AMENDMENT UNDER 37 C.F.R. § 1.111 Attorney Docket No.: Q80165

Application No.: 10/589,611

AMENDMENTS TO THE DRAWINGS

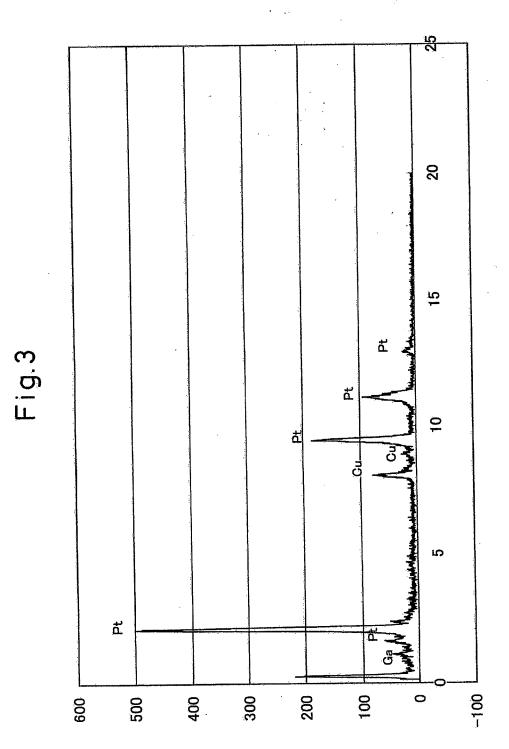
In response to the drawing objection, a replacement drawing sheet (Figure 2) is submitted

herewith to show a contact metal layer 11, a positive-electrode-metal-containing layer 6, and a

semiconductor-metal-containing layer 7.

The Examiner objected to the drawings to under 37 C.F.R. § 1.83(a) as not showing the

contact metal layer and a positive-electrode-metal-containing layer as described in the

specification.

In response to the drawing objection, a replacement drawing sheet (Figure 2) is submitted

herewith to show a contact metal layer and a positive-electrode-metal-containing layer including

identifying reference numbers. Figure 2 also shows a semiconductor-metal-containing layer,

which is described in the original claim 8.
